2CAN111702

November 20, 2017

SUBJECT: License Amendment Request  
Updating the Reactor Coolant System Pressure-Temperature Limits  
Arkansas Nuclear One, Unit 2  
Docket No. 50-368  
License No. NPF-6

**Proposed Technical Specification Changes (mark-up)**

Figure 3.4-2A

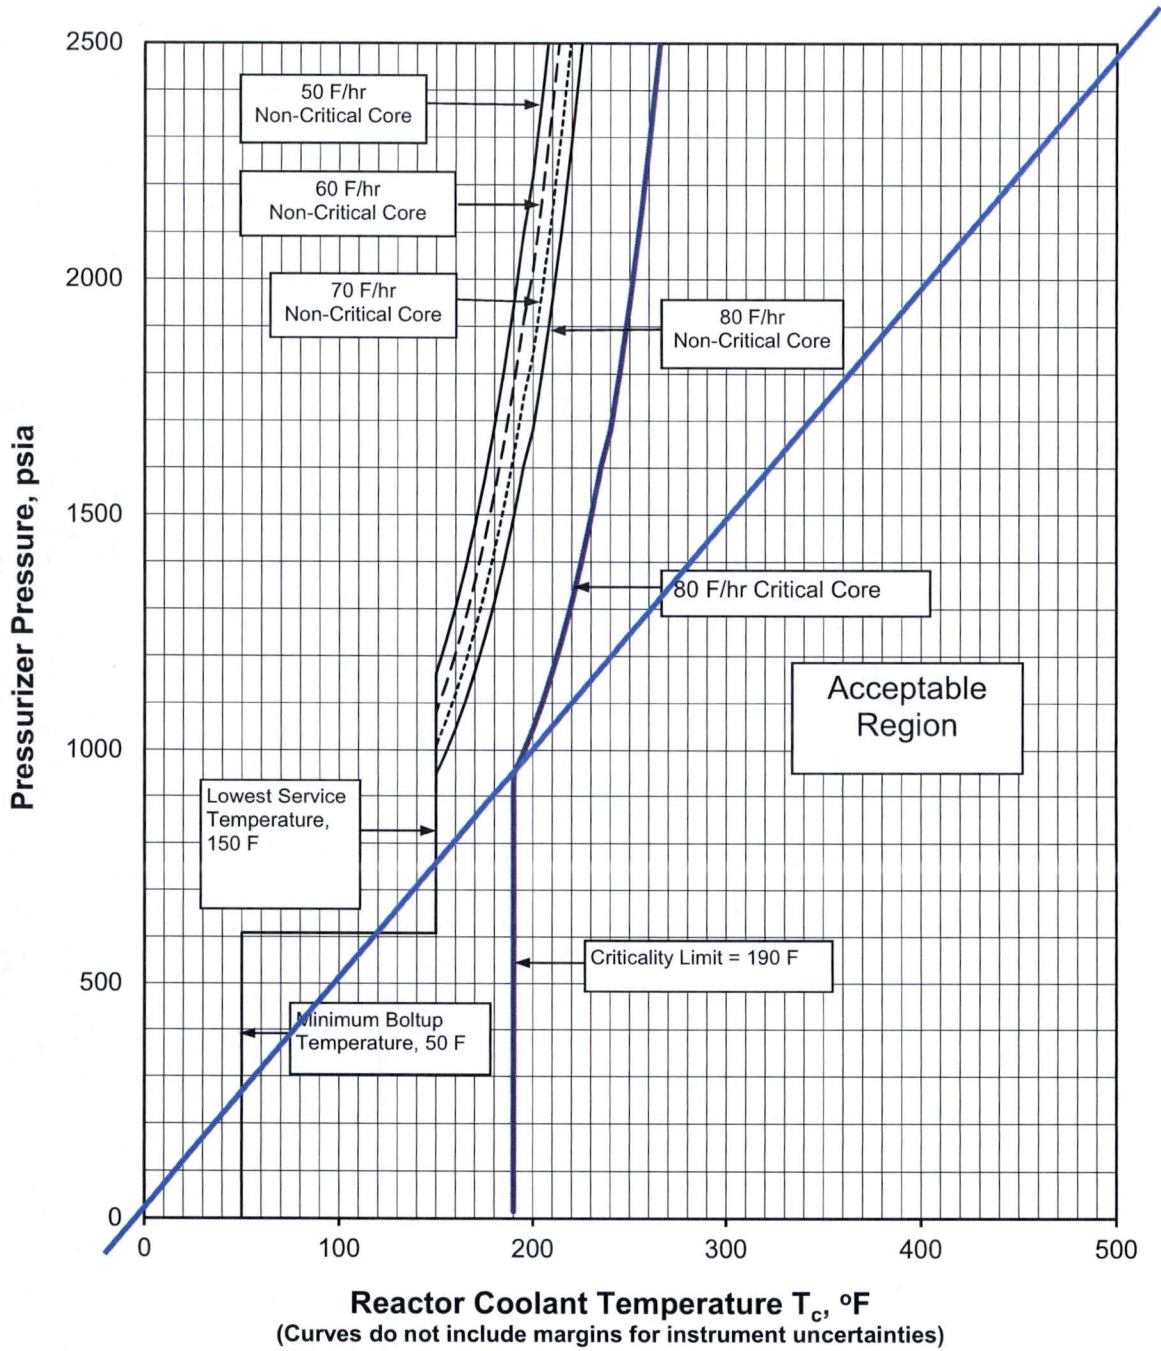
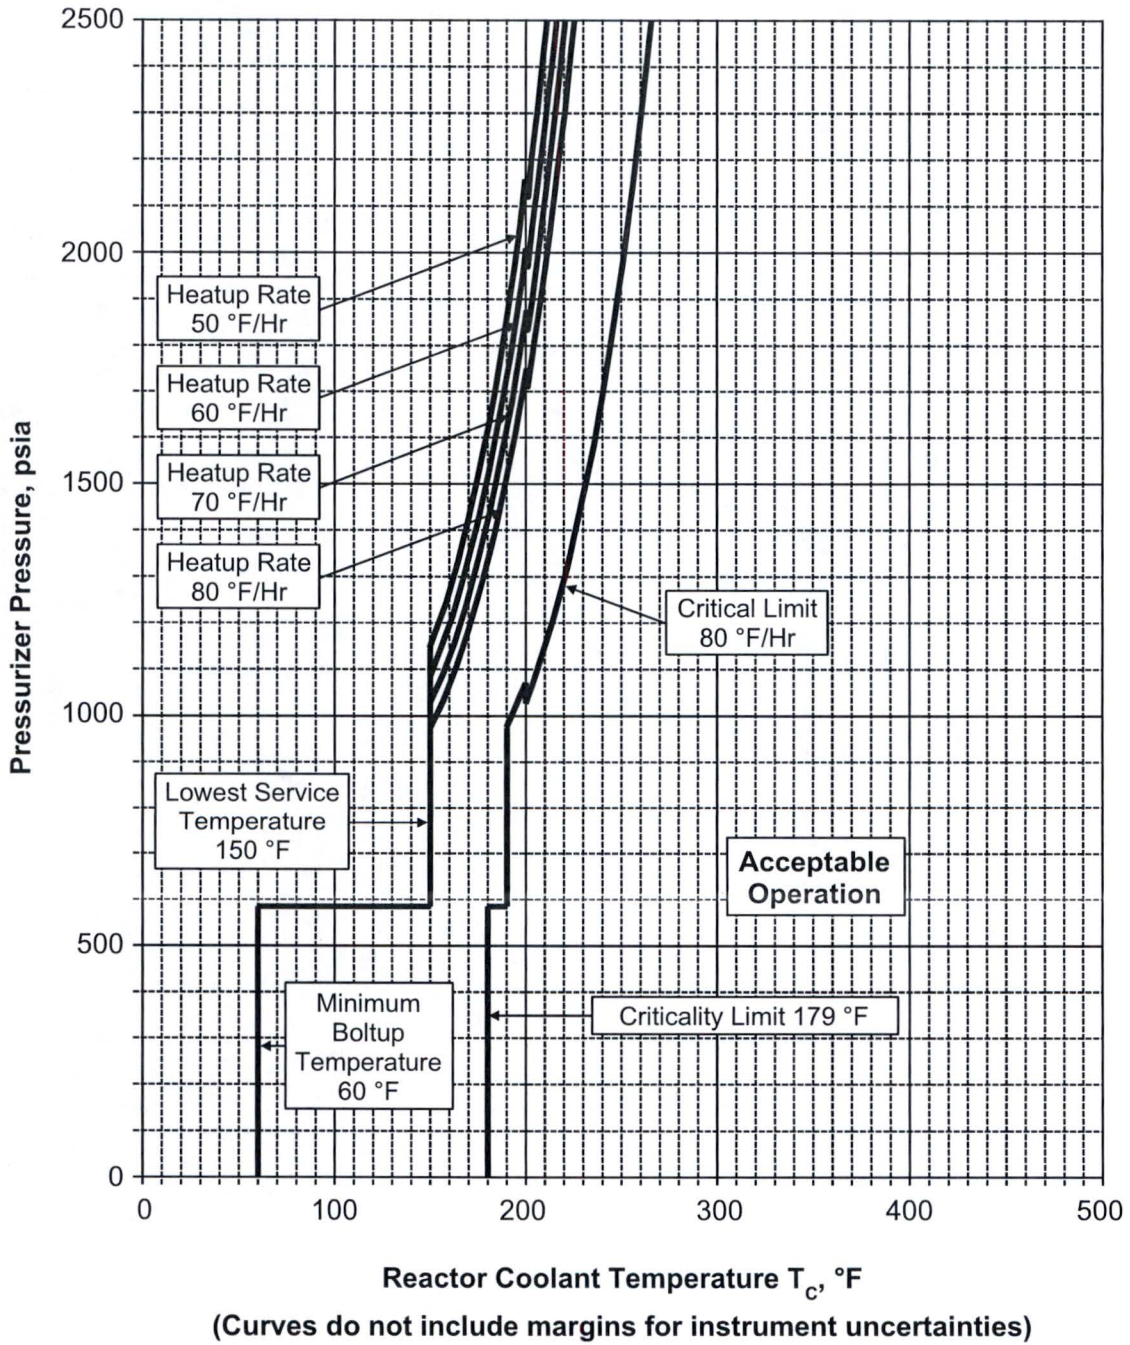
The proposed amendment would revise TS 3.4.9 to incorporate updated figures for the P-T limits. These figures have been recalculated to account for 54 EFPY of plant operation. The minimum boltup temperature for the ANO-2 vessel has been revised as well. Instrument uncertainty has not been included in these limits. The requested change involves no significant hazards consideration as outlined in Section 3.3 of this enclosure.

**HEATUP CURVE – 3254 EFPY**  
REACTOR COOLANT SYSTEM PRESSURE/TEMPERATURE LIMITS

HEATUP CURVE – 54 EFPY  
REACTOR COOLANT SYSTEM PRESSURE/TEMPERATURE LIMITS

Figure 3.4-2B

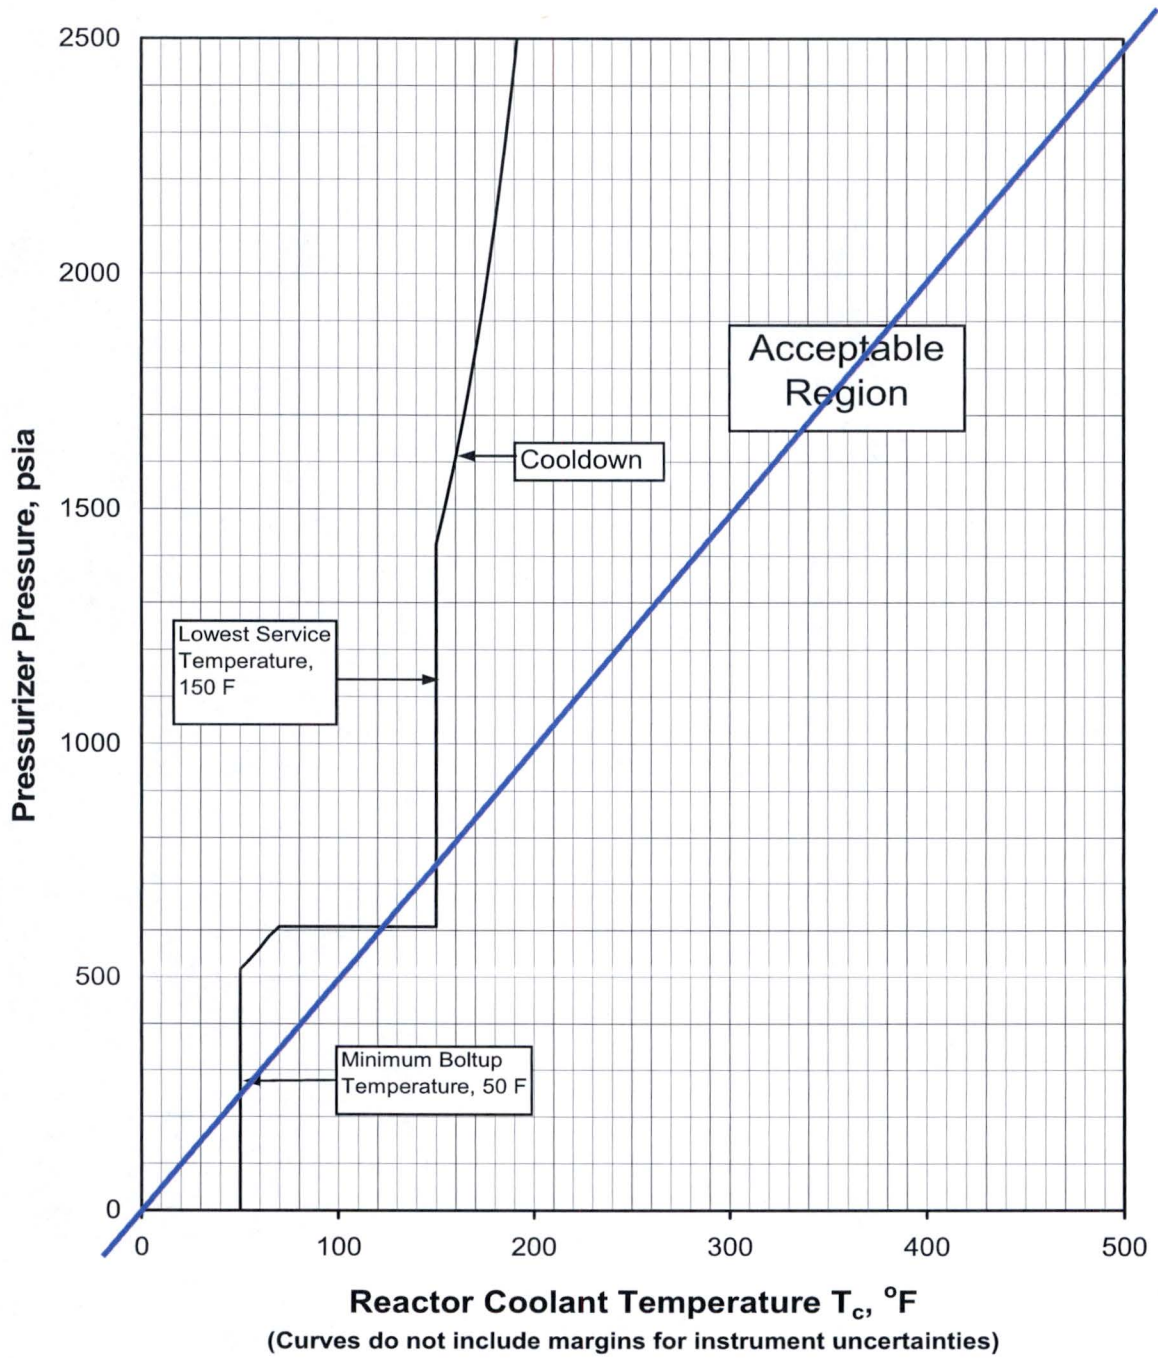
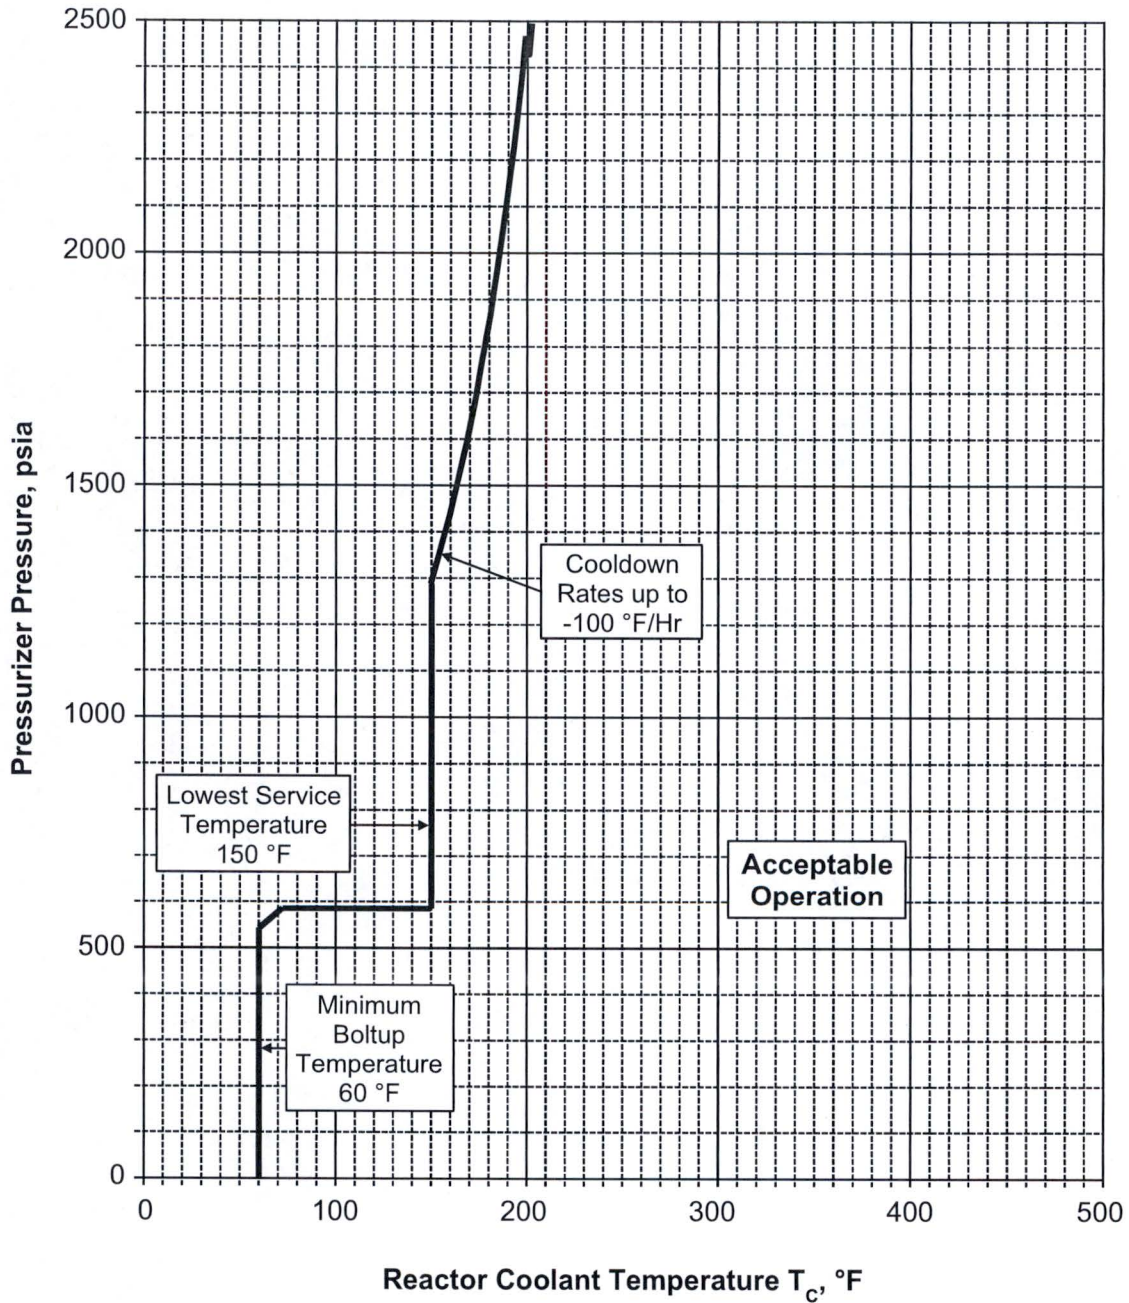
**COOLDOWN CURVE – 3254 EFPY**  
REACTOR COOLANT SYSTEM PRESSURE/TEMPERATURE LIMITS

COOLDOWN CURVE – 54 EFPY  
REACTOR COOLANT SYSTEM PRESSURE/TEMPERATURE LIMITS

Figure 3.4-2C

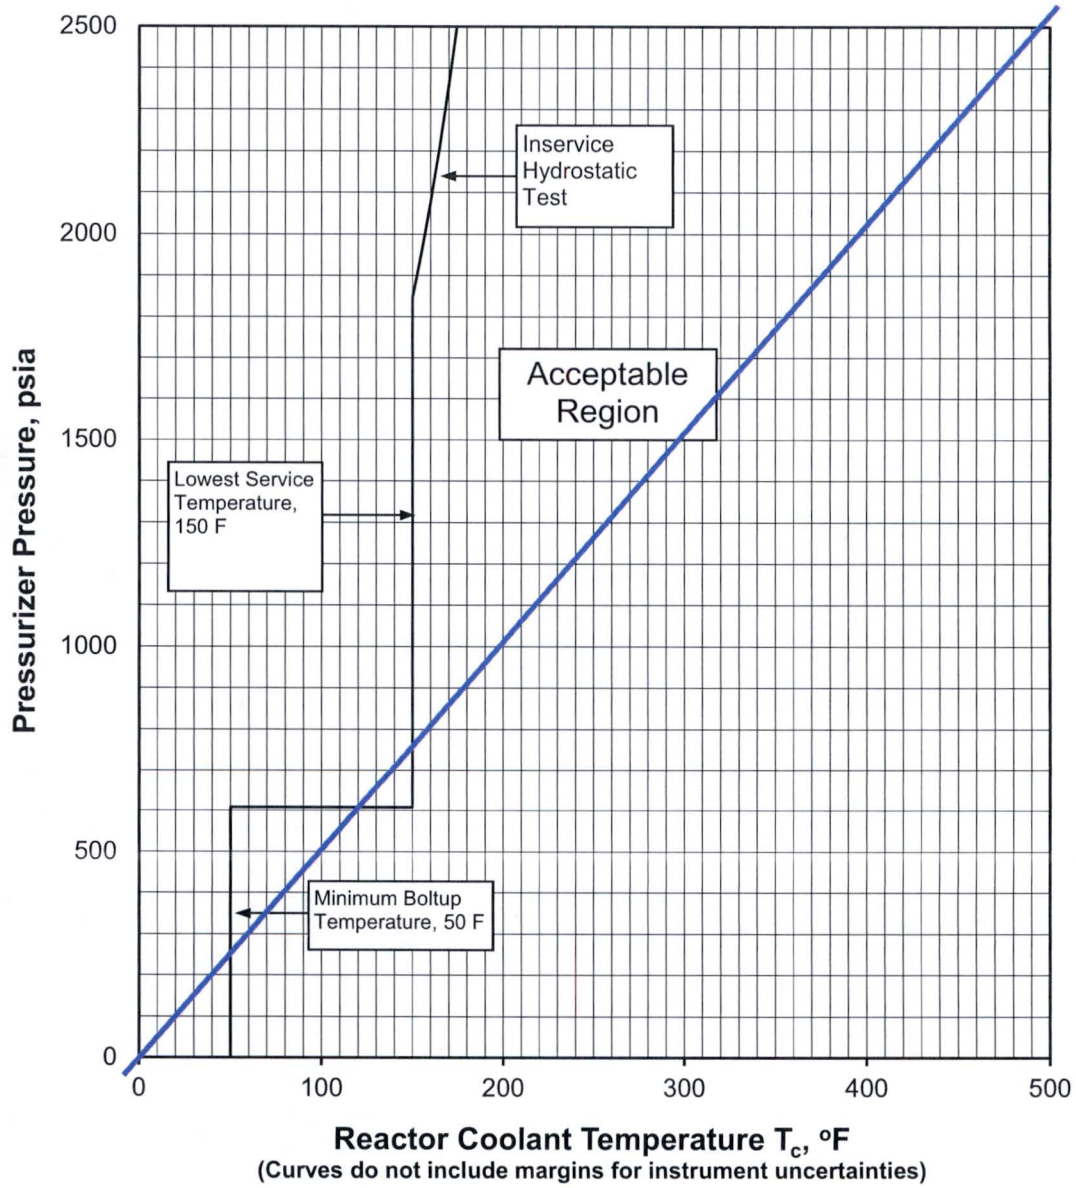
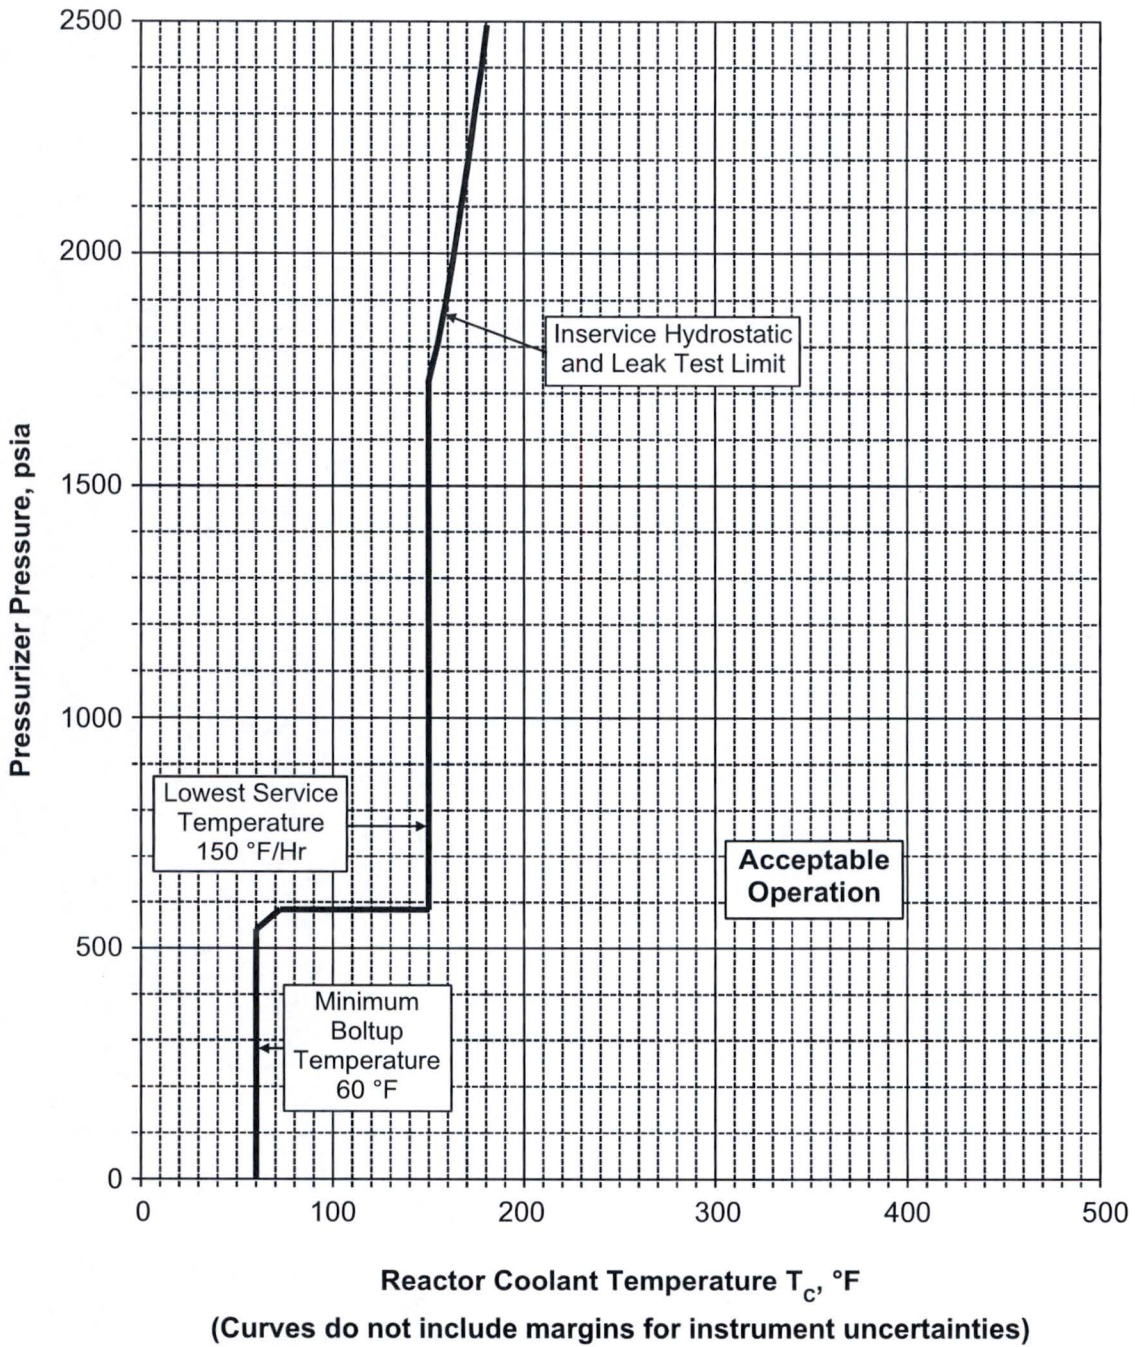
**INSERVICE HYDROSTATIC TEST CURVE - 3254 EPFY**  
**REACTOR COOLANT SYSTEM PRESSURE/TEMPERATURE LIMITS**

**INSERVICE HYDROSTATIC TEST CURVE – 54 EFPY**  
**REACTOR COOLANT SYSTEM PRESSURE/TEMPERATURE LIMITS**
